Name: Fire Station #2 - 28 1/4 Road and Patterson Road

RE: Review Comments for Sewer Service to the Proposed New
Fire Station for the Central Grand Valley Sanitation
District

I have reviewed the site plans for Fire Station No. 2 which were received on November 7, 1991 and have the following comments:

A
L1.1 LANDSCAPING PLAN
1" = 20'-0"

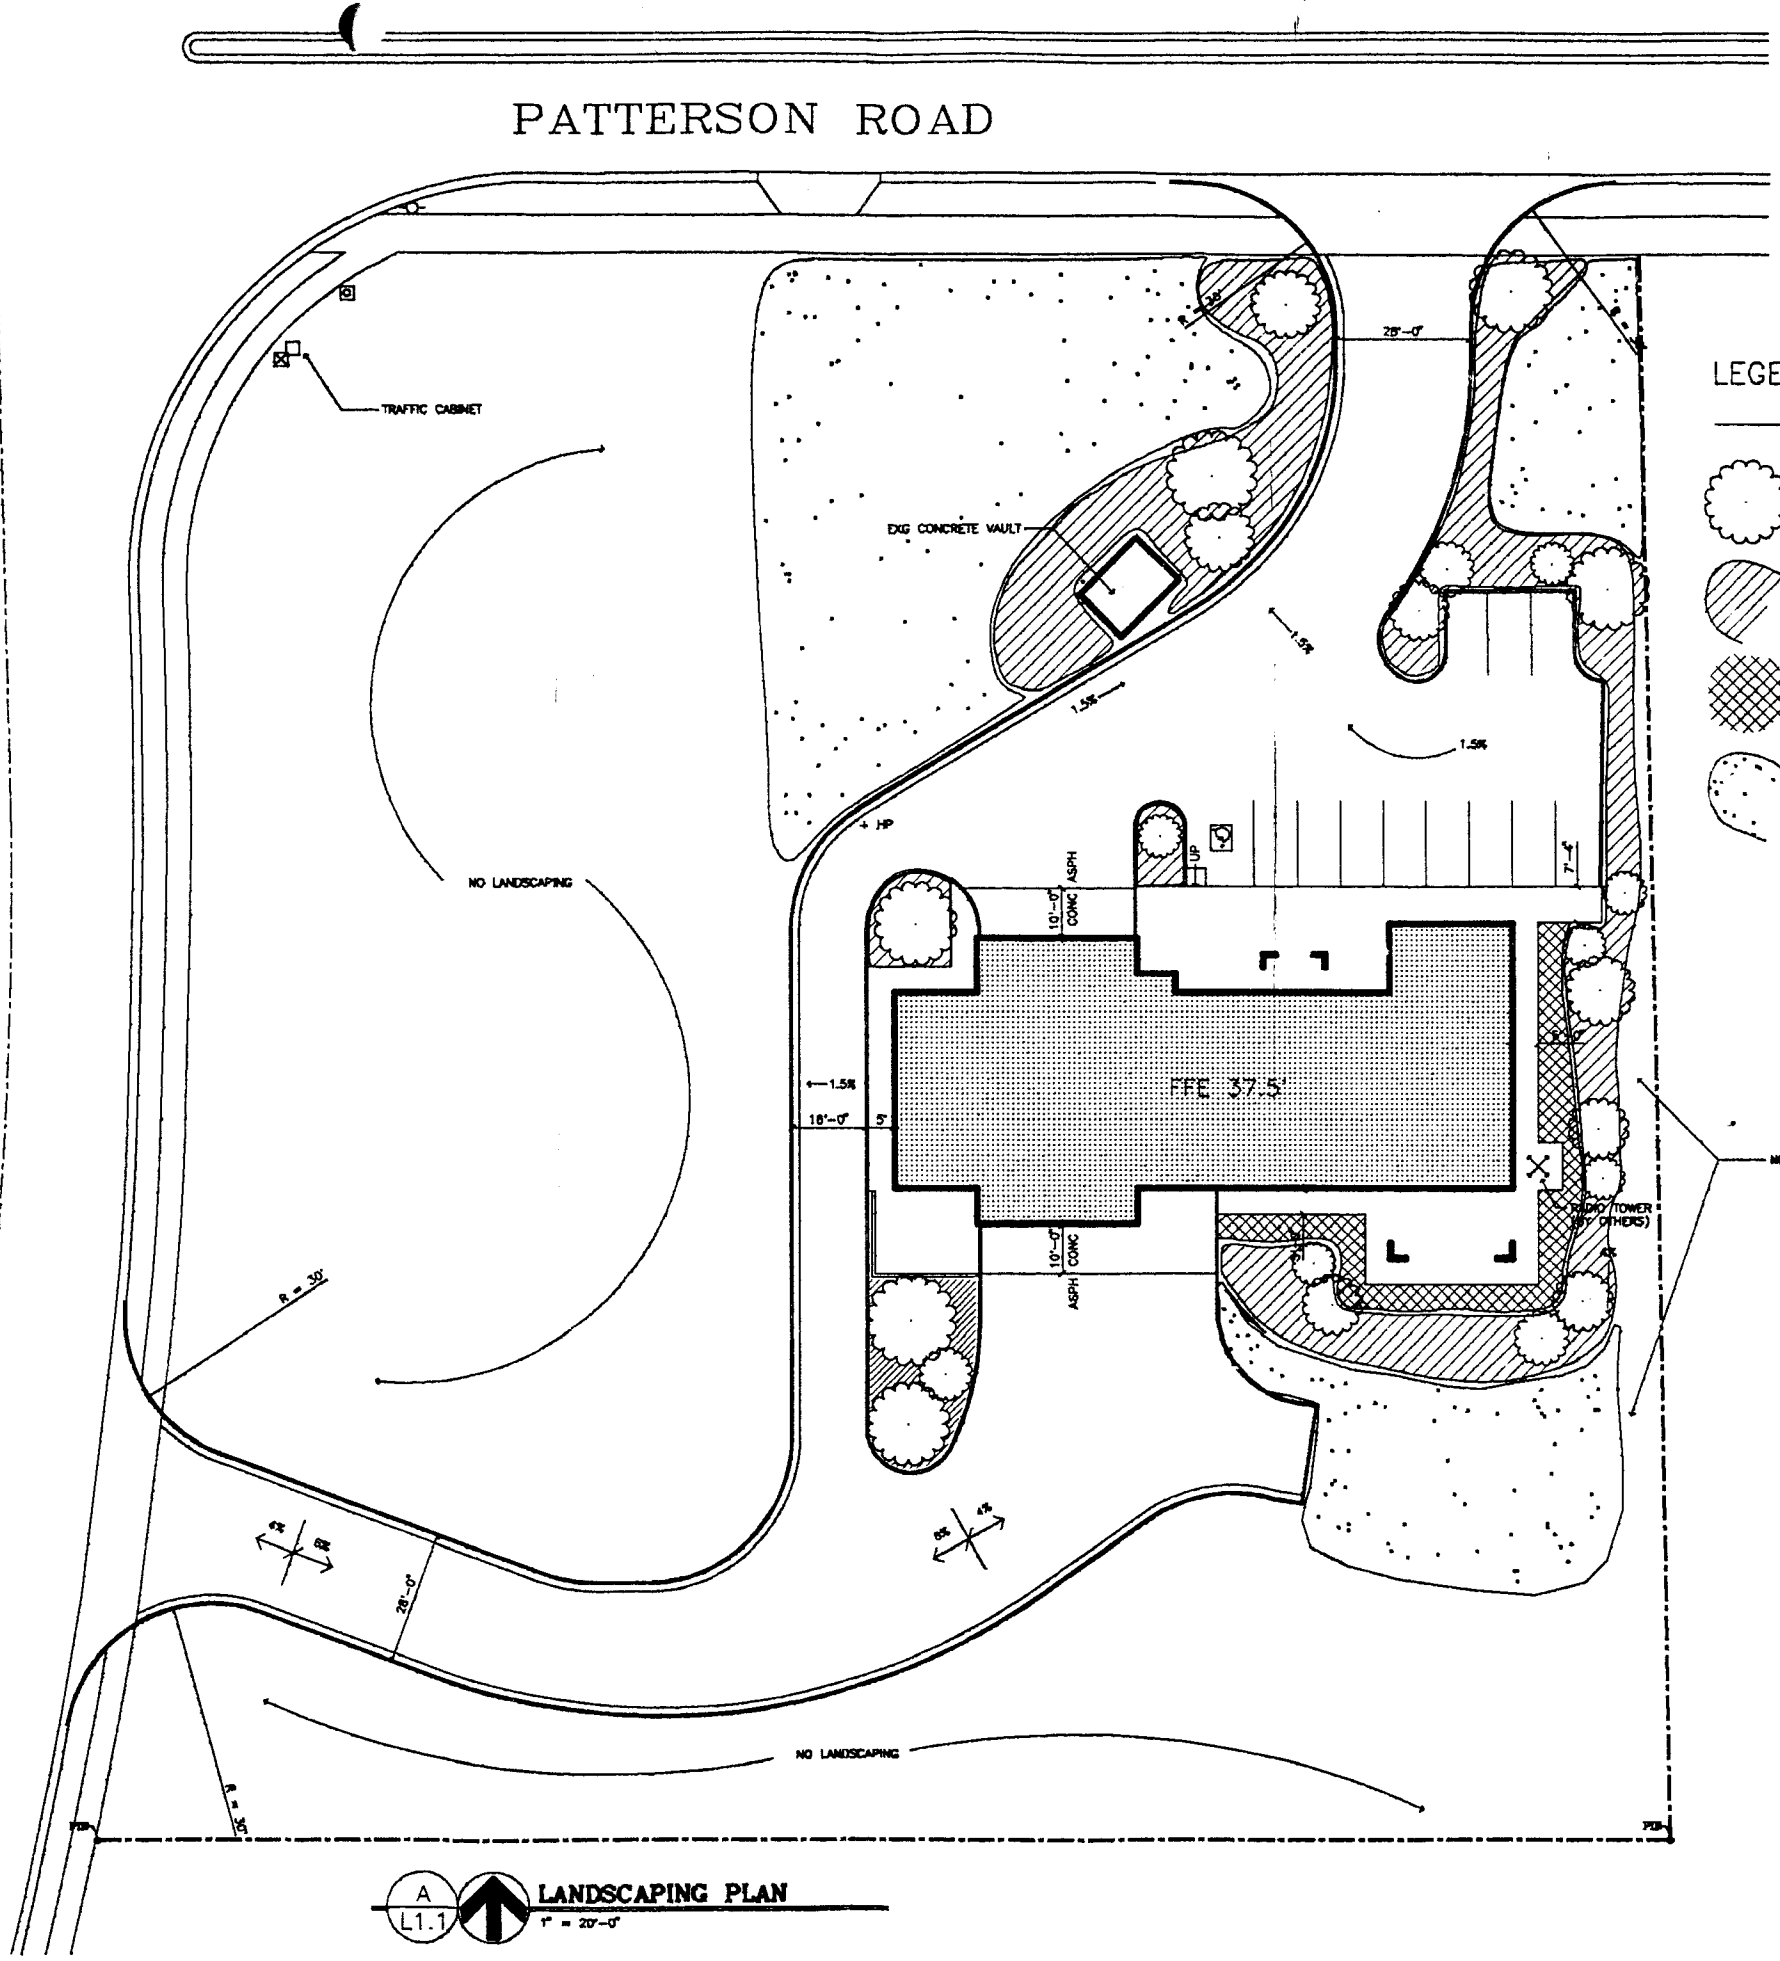
2. Where site drainage is to be diverted into and out of the storm water detention ponds, the curbing, gutters and piping are not constructed in accordance with details prepared by the Chamberlin Architects. As a result, water flowing along the curb cannot get into the detention ponds. Also where the detention ponds discharge pipes intersect the street curb there is supposed to be a concrete transition between the pipes and the curb. These transitions do not exist.

3. Where drainage leaves the curb and gutter and enters a concrete V pan at the top of the south driveway, the gutter is sloped in the wrong direction trapping water against the curb. This curb, gutter and pan will need to be reconstructed to properly drain.

These items should be corrected prior to final payment to the contractor and issuing of a C.O.

A SITE PLAN
C1.0
1" = 20'-0"

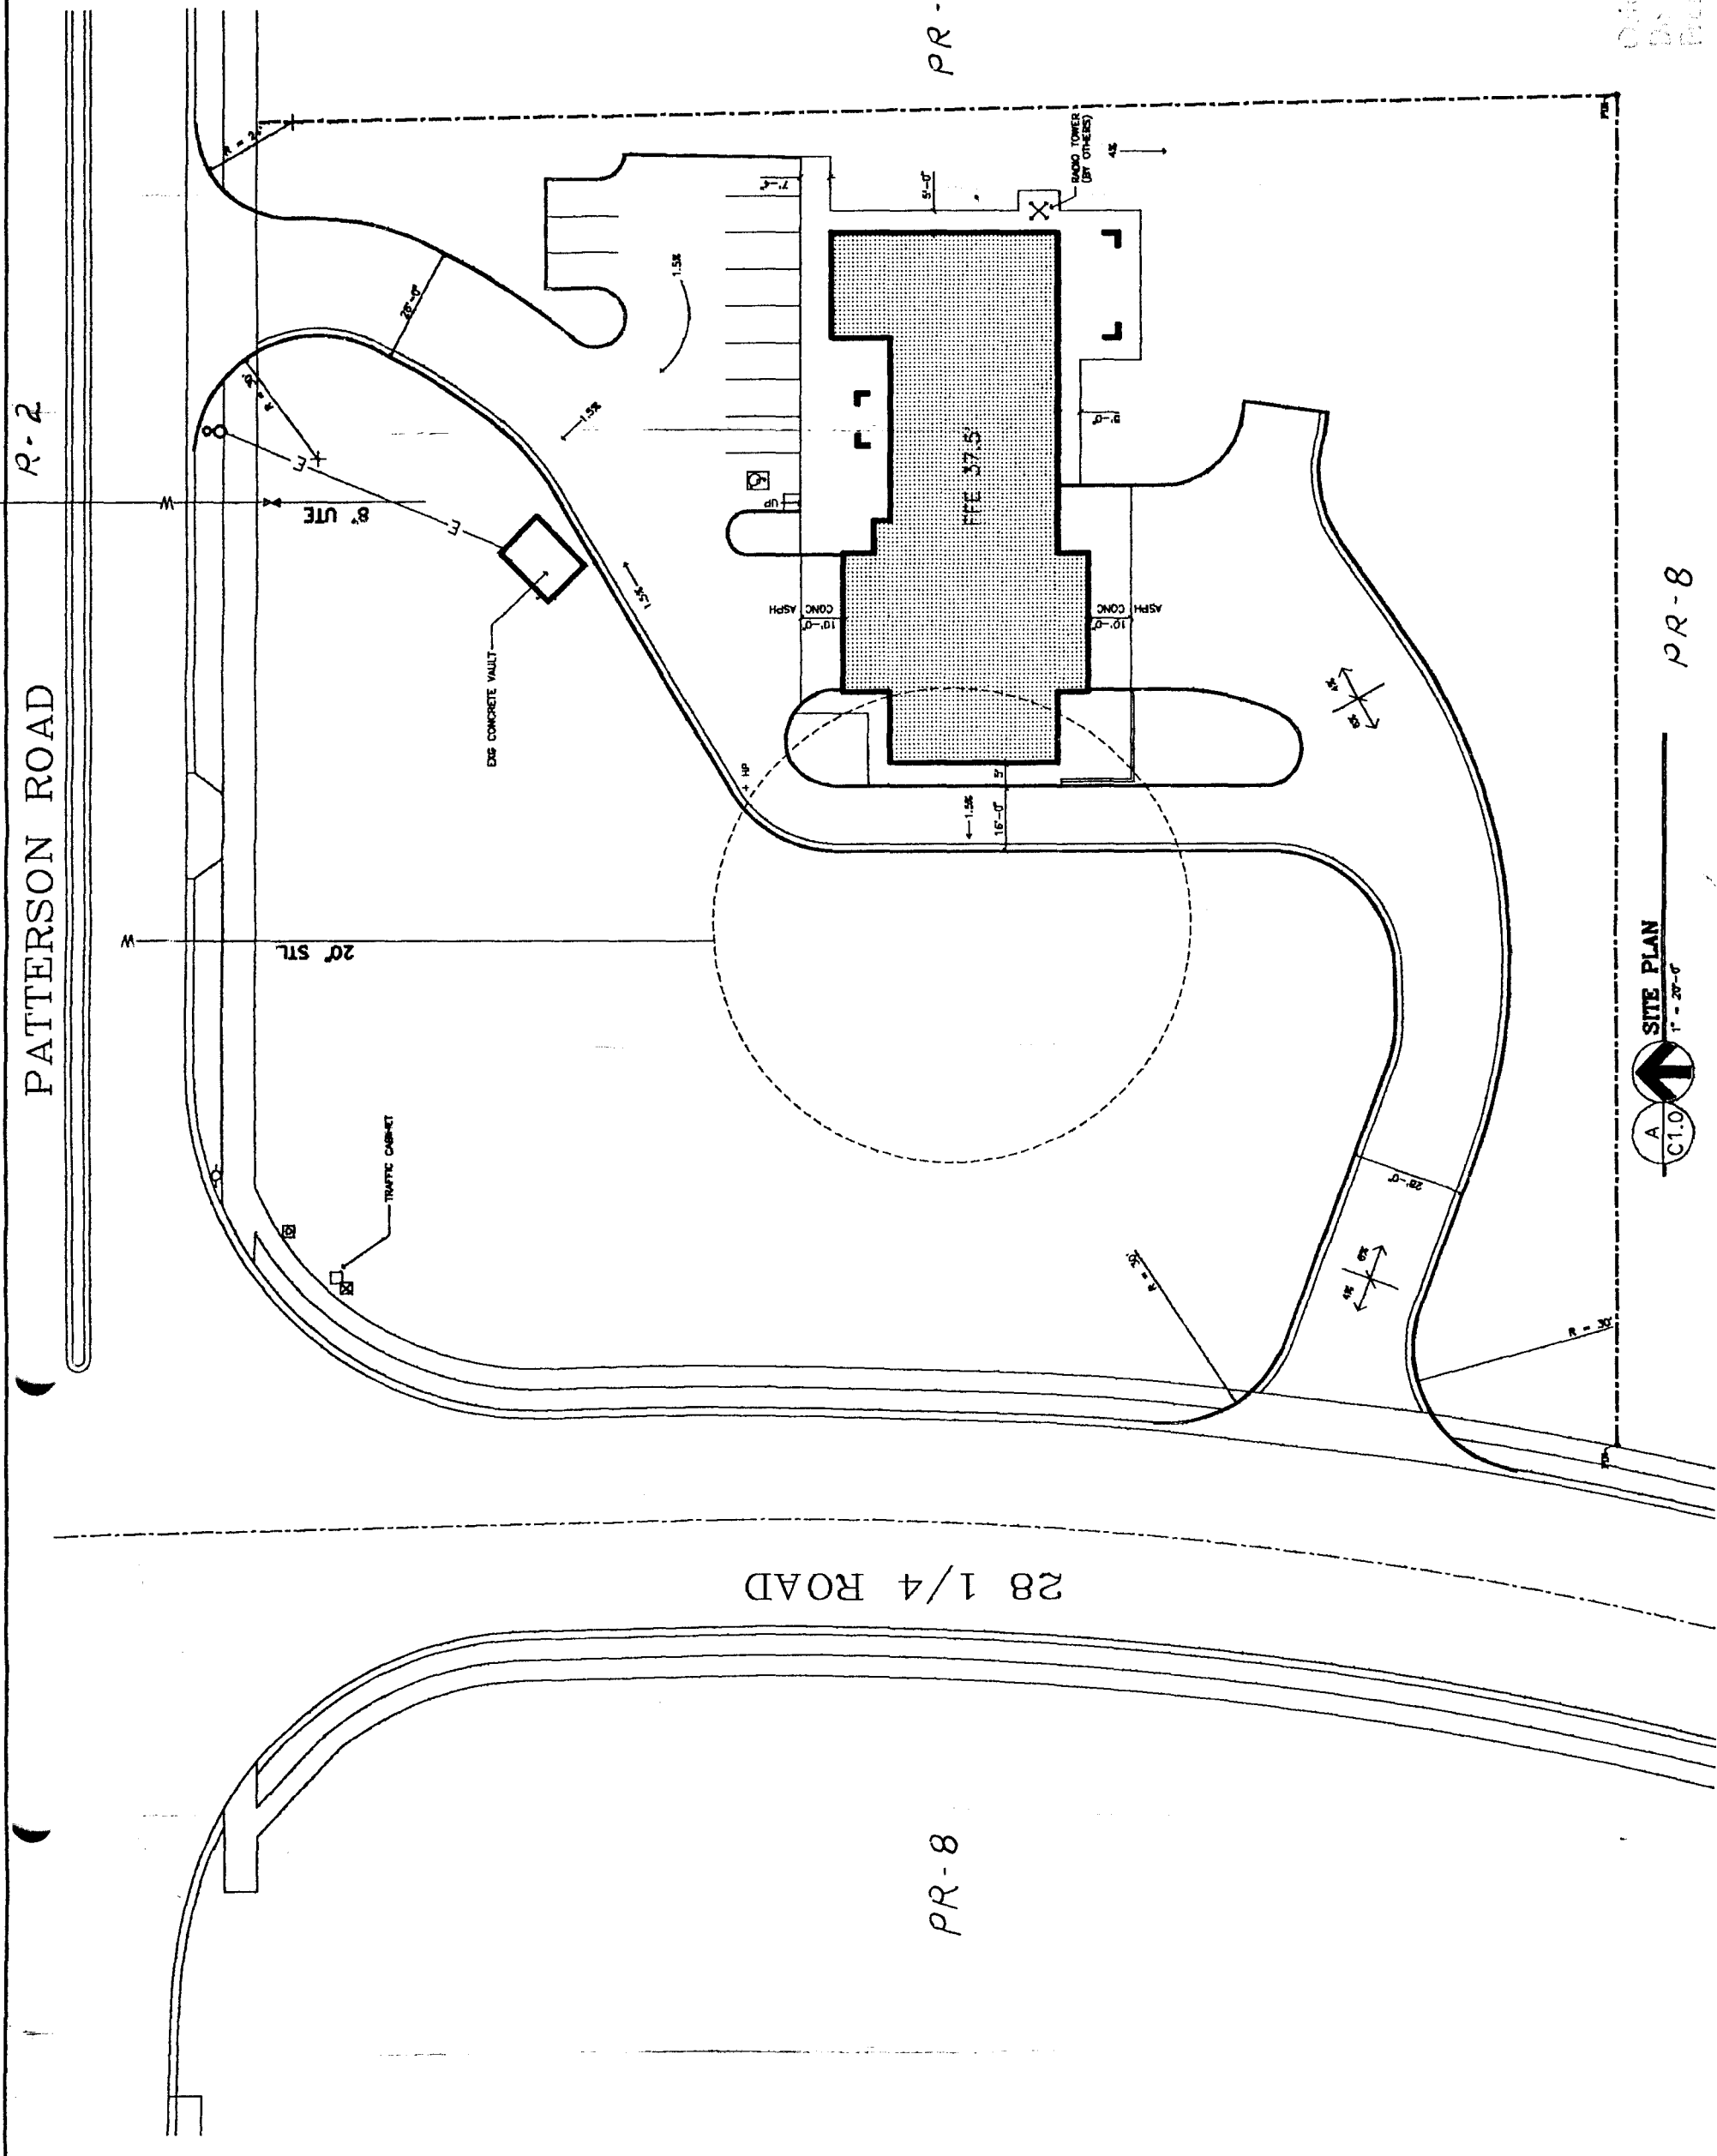
The site plans are incomplete. The following information will need to be submitted for my review:

1. Site grading and drainage plan showing existing and proposed contours at one foot intervals.
2. Drainage calculations for historic and developed conditions. On site detention of runoff in excess on historic rates will be required. Detention volume should be calculated using the modified rational method of other approved procedures.

3. Horizontal and vertical control for location and layout of all site paving and concrete curbing, gutter, sidewalk, driveways, utilities, etc.
4. Copy of soil report including building foundation design and pavement design calculations.

5. Details and structural sections for all concrete and asphalt pavement.
6. Details of any earth retaining structures that may be required.
7. Show description of the property boundaries and dimensions of parking lot layout.
